Evergreen Consulting
Environmental and Urban Planning

S92 response - APP-2025205512.00

Thank you for your letter dated 26 November 2025 requesting further information in respect of a number of matters. Below details responses from Mr Jon Bell, Principal Engineer, e2 Environmental Limited and Dr Mark Heath, Freshwater Scientist, Traverse Environmental. In addition, we have a further response from Ngati Rangi.

The below image shows the ponding upstream of the structure (Taken 1 August 2025).

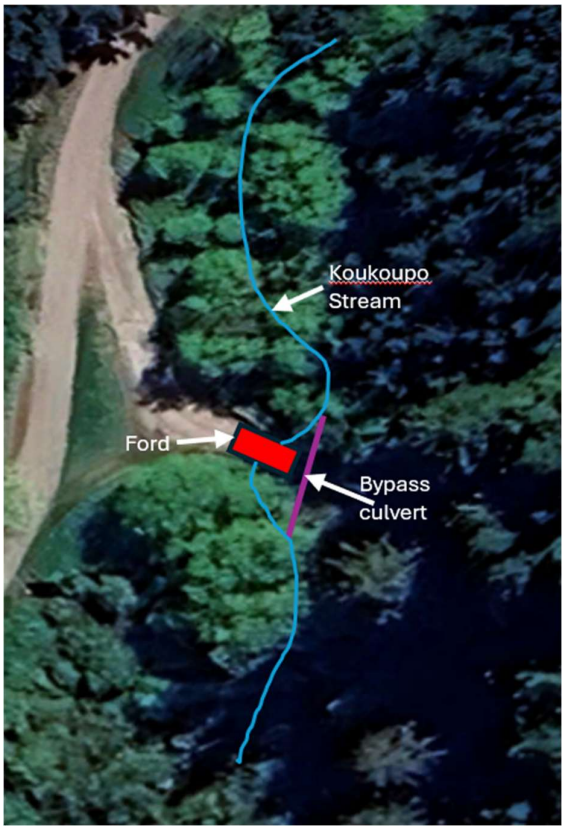
5. *The water velocity and depth within the bypass culvert will be highly dependent on the amount of stream flow entering the bypass pipe. The engineering report assumes the pipe would take 50% of stream flow at 1%MAF and 40% at 10%MAF. Please provide further information on how these proportions of flow were determined. Given the dynamic nature of waterways, particularly steep streams such as this one, what degree of certainty is there regarding the proportion of flow entering the bypass culvert. Please provide information if there a risk that either too little or too much water will enter the bypass, potentially impacting fish passage.*

"The proportions of flow have come from the results of the HY-8 modelling. Whilst the stream overall is steep, it is noted that the short reach immediately upstream of the ford is relatively flat and significantly wider than the upstream and downstream reaches per figure 2 of my memo, attached as appendix 5 to the application. The presence of the ford leads to some heading up 'ponding' of the water in this area providing an element of control on the water levels at the inlet of the by-pass culvert.

Whilst this provides some confidence in the proportion of water that will flow via the bypass culvert, it is noted that the bed levels of the stream may fluctuate as gravels are moved by high flows events. In this regard the risk of the bed dropping is considered to be low due to the fact that the structure is close to the Papa bedrock. The more significant risk to the proportion of flows being altered by natural processes is therefore gravels being deposited that reduce flows in either the bypass culvert or the ford. This risk could be mitigated by the relocation of any gravels that are obstructing flows as part of maintenance activities."

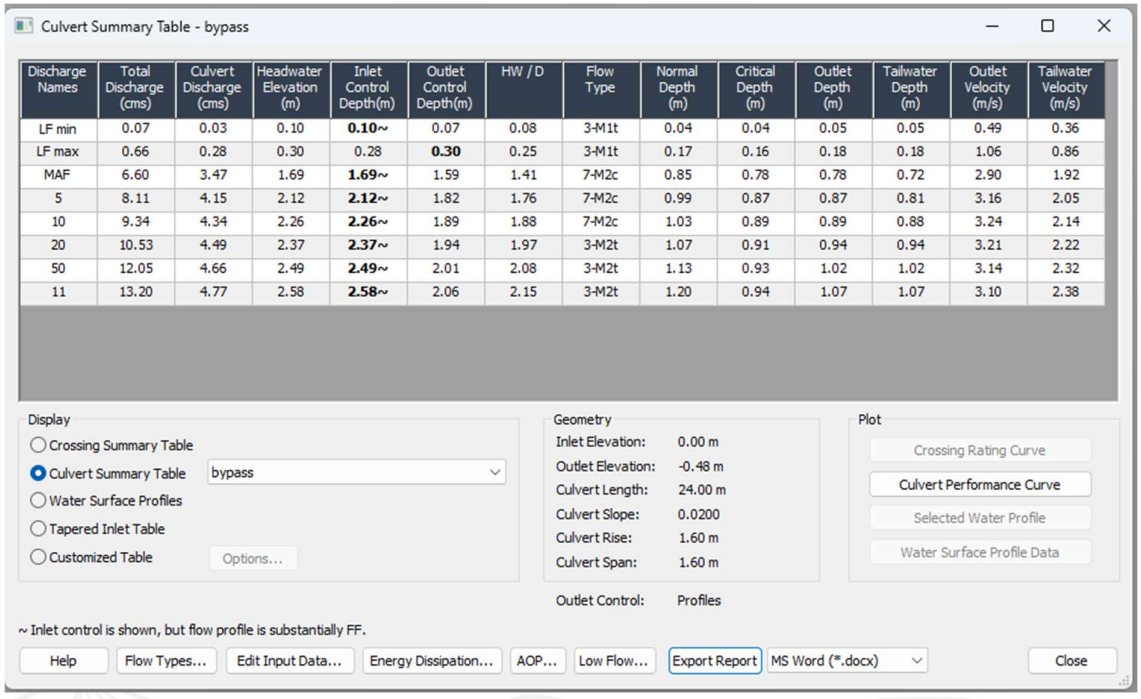
8. *The geometry of the bypass culvert appears from Figure 4. In the E2 Environmental Report to require at least one change of direction to get around the existing structure. Please confirm if manholes are proposed.*

Mr Bell has confirmed that no man holes are proposed. Mr Bell further notes the perspective of figure 4 in his memo provides a false impression of a curvature. Mr Bell confirms "The culvert will infact be straight, as the ford actually takes the stream around a bend (around the alignment of the original bridge). This is indicated on the sketch below.

Any small curvature that may be required in the bypass culvert will be created through small angular deflections at the joints (with in the manufacturer's tolerances)"
